P5001A-03

Information Only Service Note

P5001A Keysight Streamline USB Vector Network Analyzer

False alarm on self-test failure on firmware revision of A.13.40.02 - DDR3 memory removal

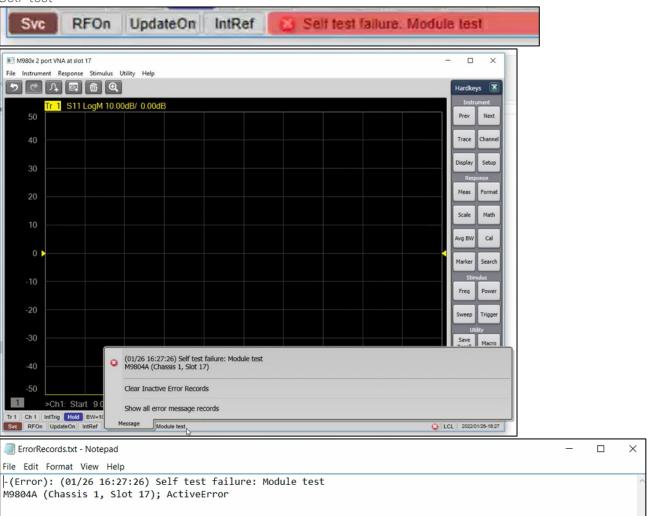
The on board DDR 3 memory in VNA is not in use since its release. With the removal of DDR 3 memory IC on newer P500xA VNA, right after firmware is launched, false alarm (self-test failure) will be reported as shown. This has no impact to VNA performance and specifications.

Similarly, firmware will report a false failure in Operator check. Shown are the error messages example on VNA firmware UI.

Since this DDR3 memory is not in use, newer firmware revision no longer consider it as the failure. Keysight recommends keeping VNA firmware up-to-date whenever it is possible.

For users with firmware revision of A.13.40.02, Update firmware to revision A.13.70.02 or newer to resolve this false alarm on self-test.
